2009 IBC Nonstructural Question and Answer

Figure 7-46

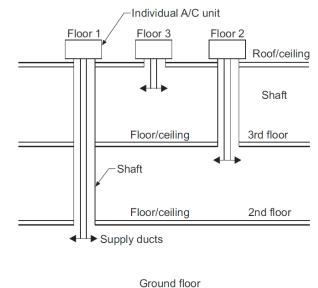
Q: Is it necessary to install dampers at the bottom of shafts as illustrated in Figure 7-46?

A: Essentially, you are asking whether the schemes indicated in Figure 7-46 meet the intent of Exception 1 of Section 708.11 without providing fire and smoke dampers. The figure shows a three-story building with the air-conditioning units for each of the floor levels located on the roof. The shaft construction for each air-conditioning unit runs down to the floor level served by the air-conditioner without any openings in the shaft from any floor level except the floor level that it is supplying. Because intercommunication between the various floor levels would not be created by this method, there would not be any need for the installation of dampers in the individual air-conditioning shafts. [7-46]
